## ADDENDUM

**ADDENDUM NO.:** 04  
**PROJECT NAME:** Emergency Medical Services (EMS) Addition  
**PROJECT NO.:** 07215  
**CONTRACT NO.:** C1611  
**DATE OF ISSUE:** July 31, 2024

### NOTICE OF CHANGES, MODIFICATIONS, OR CLARIFICATIONS TO CONTRACT DOCUMENTS

**E102**

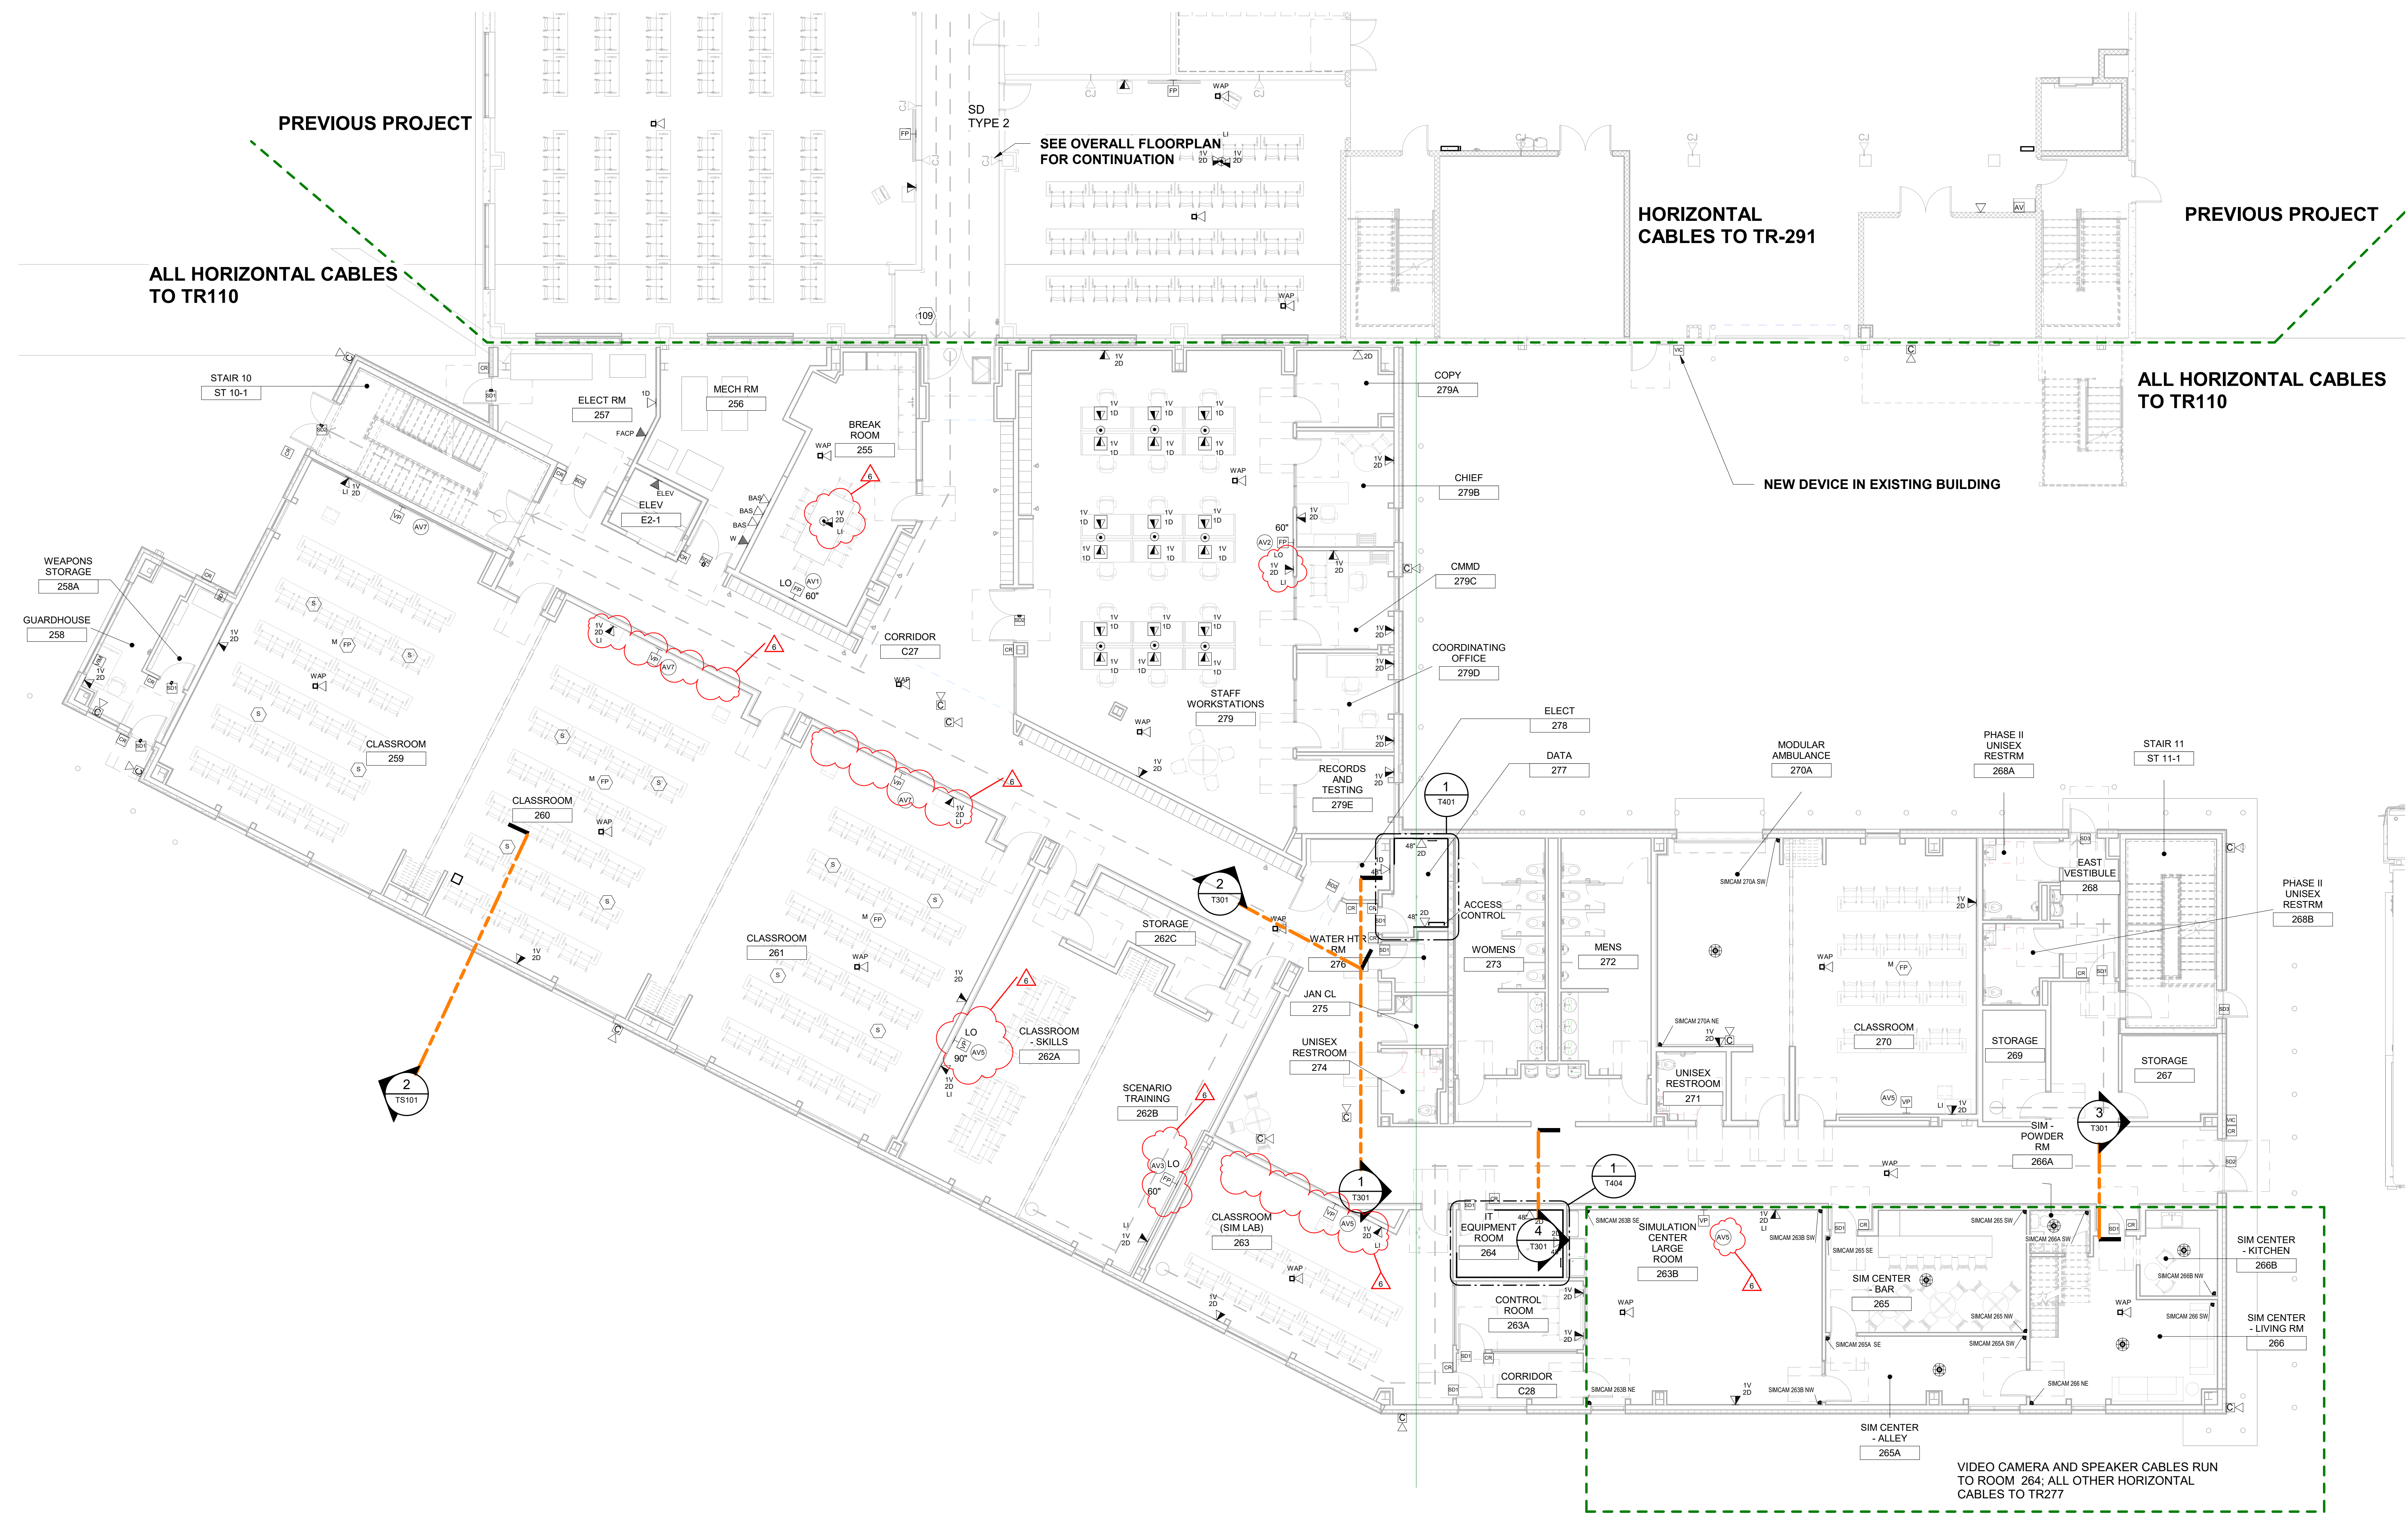
- Change 25** **REVISED** Drawing No. E101 – Updated mechanical VSDs equipment and plumbing equipment tags.
- Change 26** **REVISED** Drawing No. E102 – Updated the circuits to wall mounted furniture hardware/quad receptacles.

**Question:** Power Drawing E102 shows poke through floor fittings in Room 355. Drawing T121 shows column mounted devices, not floor fittings. Please provide a specification for the power poke through fitting, and clarify if data cabling work is to be done at the work stations in the room.

**Response:** As per the bid documents, Sheet E102 shows all electrical through floor fittings. See also revised "General Requirements for Raceways" Notes 8, 11, and 12 on revised Sheet E001 included in this Addendum 4, which specify the type of power floor fittings. Per Sheet T120 data for this room to be supplied from the columns.
